# Technical Memorandum

To: Columbia County Commissioners Date: January 24, 2024  
From: Brian Tino, PE, Maul Foster & Alongi, Inc. Project No.: M1724.01.004  
Re: Response to Beaver Drainage Improvement Company Letter to the Columbia County Planning Commission and Columbia County Commission

FIGURE  
1

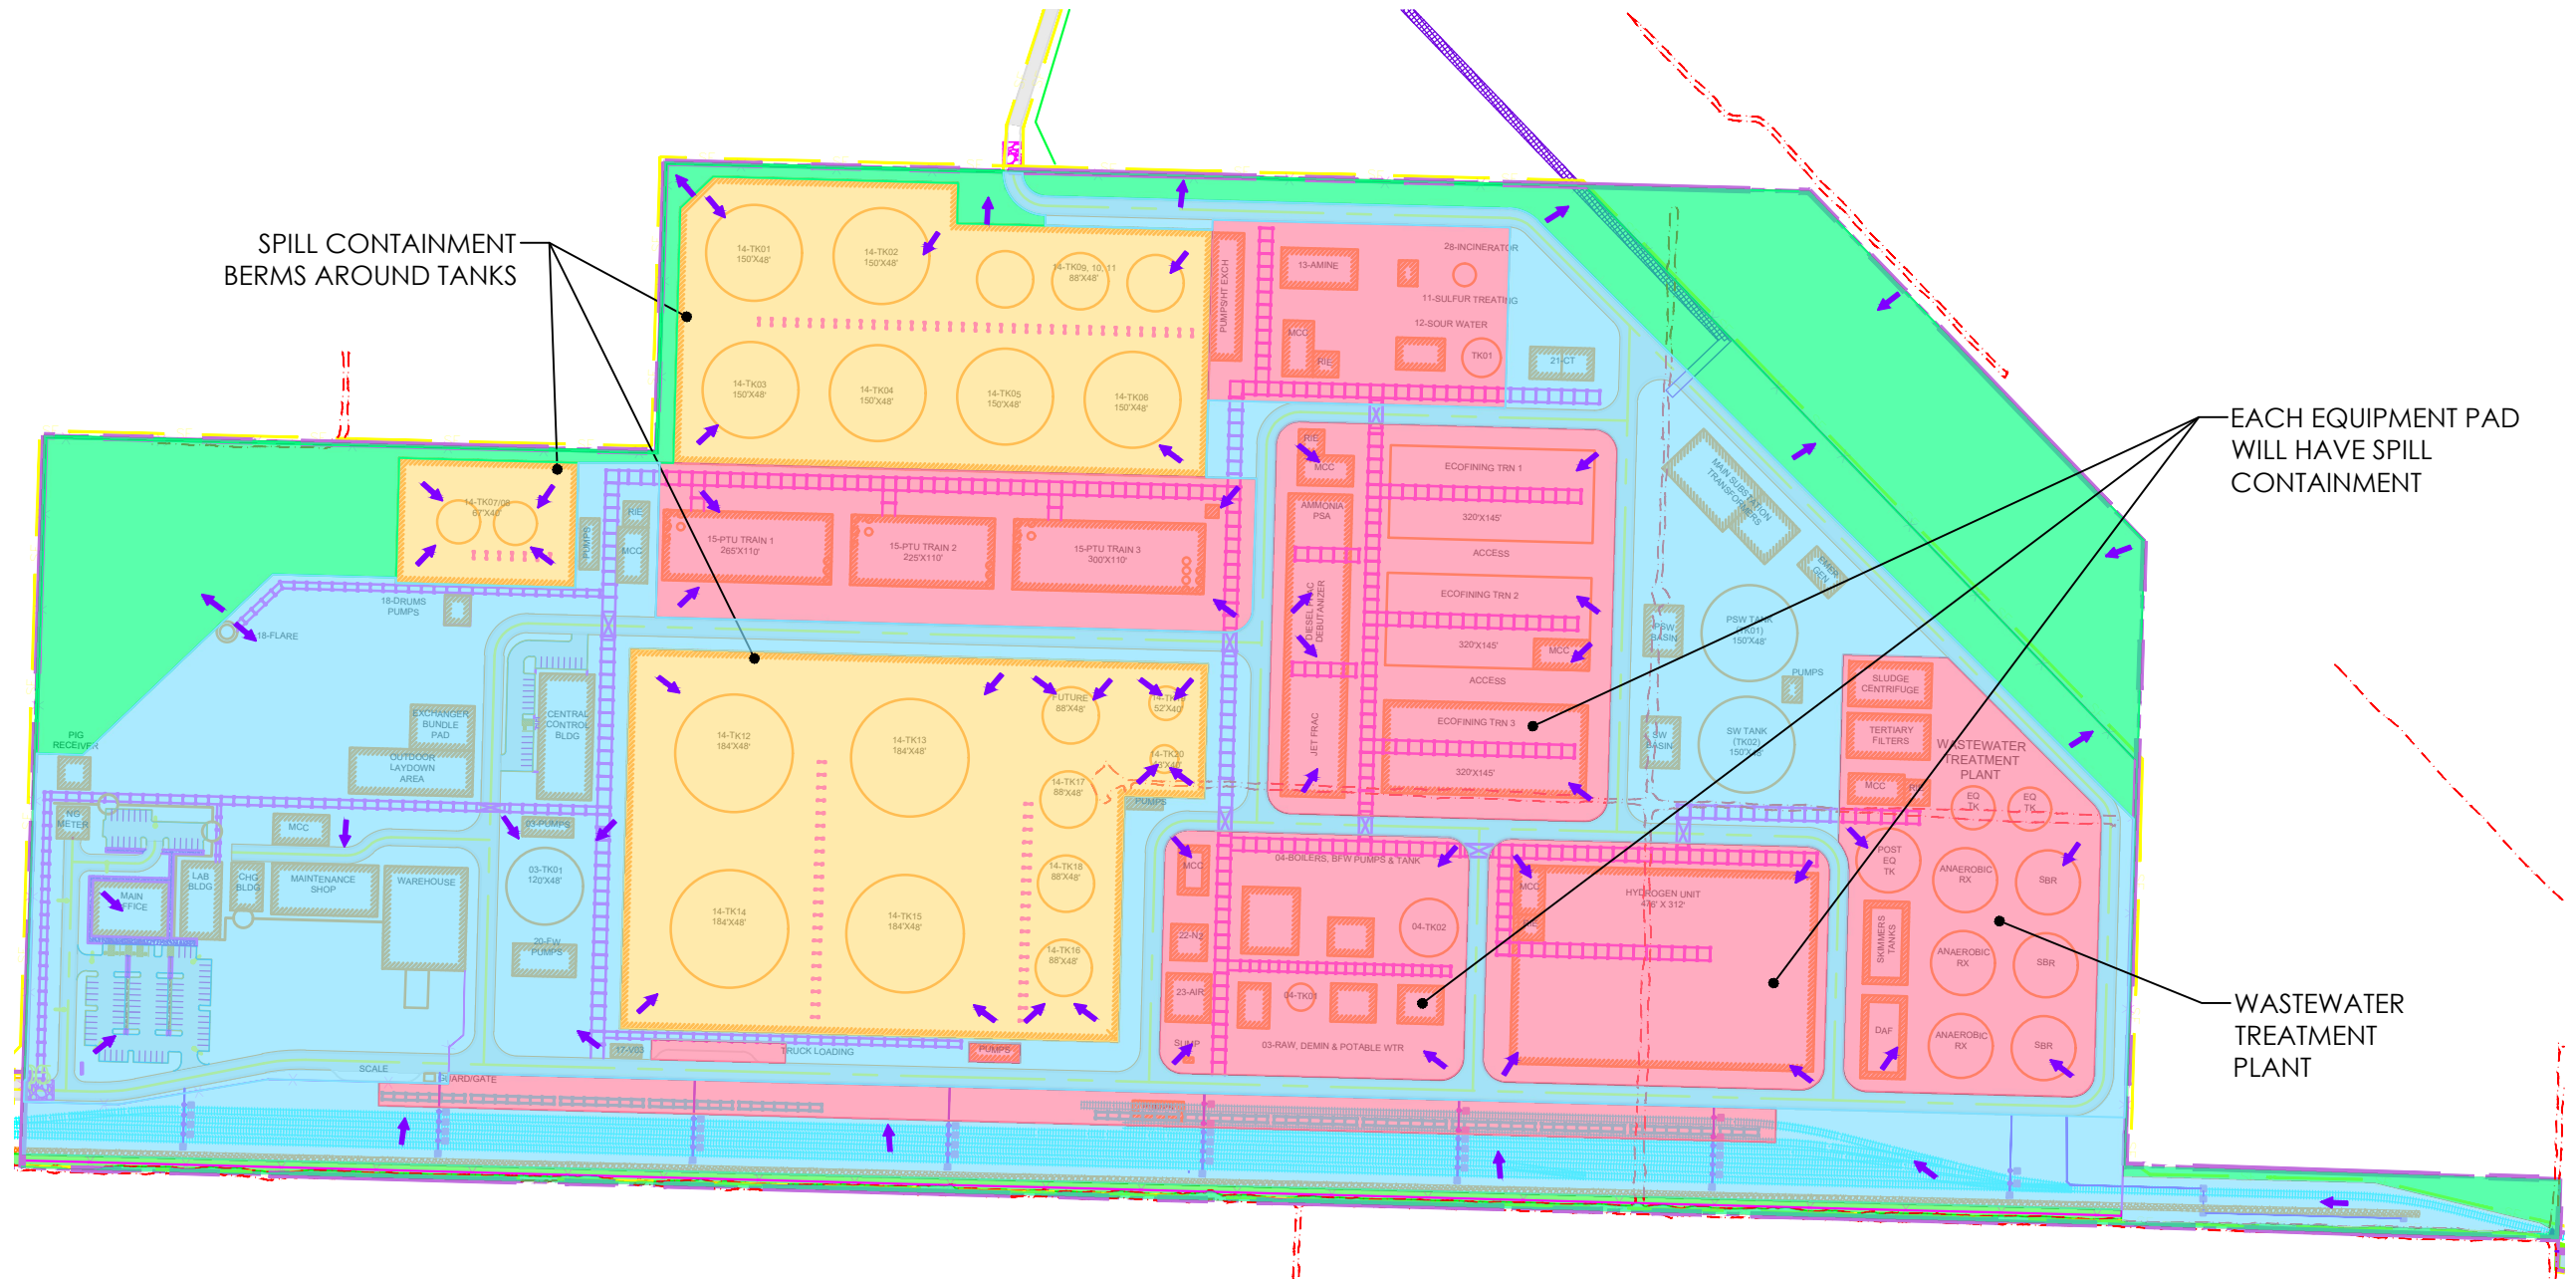
- *Spill containment plans for the facility and rail yard must be approved by the BDIC prior to any County approval of this proposal.*
- *No ditch or waterway alterations have been approved by the BDIC Board. Without specific agreements with the BDIC, NEXT cannot claim to have addressed impacts to the BDIC, its resources, or its operations. Further, the BDIC's activities are a recognized land use in the area that is vital to the overall function of the Port Westward area, including the industrial areas. NEXT fails to adequately address conflicts with BDIC's use of the area, its control of the land, and the public services it provides.*

- *Spill control will be provided by the berms around the tanks containing oil and containment around the equipment pads (see Figure 1). A comprehensive Spill Prevention, Control, and Countermeasure plan will be developed during final design of the facility.*
